Serial No.: 10/006,171 Examiner: Henry N. Tran

For: INDUCTIVE POWER SOURCE FOR PERIPHERAL DEVICES

RESPONSE TO OFFICE ACTION

FIG. 4

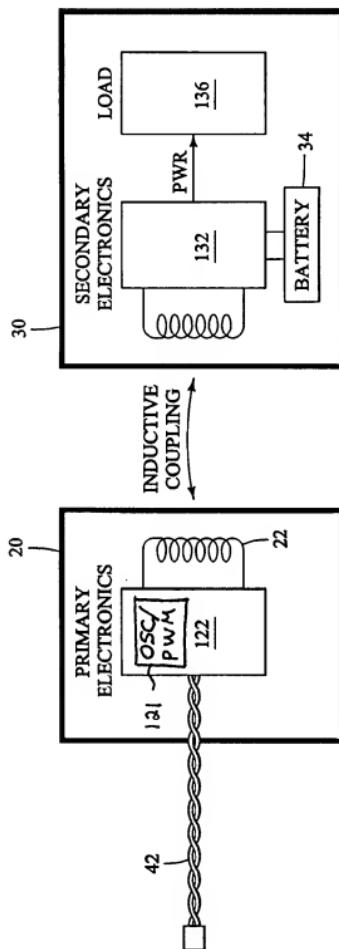
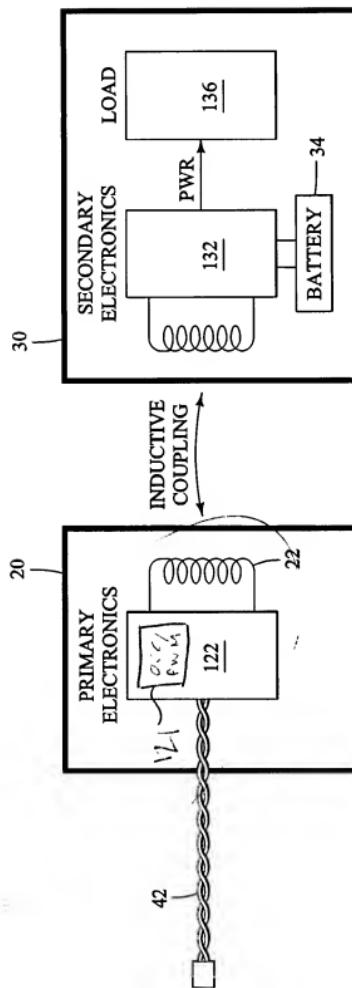
The drawings are objected to for failing to show various features recited in the claims. Applicant traverses this objection.

An embodiment of a “mouse positional circuit” recited in claim 16 is shown as item 136 in Fig. 4 and described in the specification at page 10, lines 23-27

An embodiment of a “source loop signal generator” recited in claims 18 and 19 is shown as item 122 in Fig. 4 and described in the specification at page 9, lines 9-12.

Attached is a proposed Replacement Sheet showing a revised Fig. 4. Also included is an Annotated Sheet showing in detail the changes made.

An embodiment of an “oscillator circuit” as recited in claim 19 is shown as item 121 in revised Fig. 4. Support for this drawing revision may be found in the specification at page 9, lines 13-16.

An embodiment of a “pulse width modulation circuit” as recited in claim 29 is shown as item 121 in revised Fig. 4. Support for this drawing revision may be found in the specification at page 9, lines 13-16.
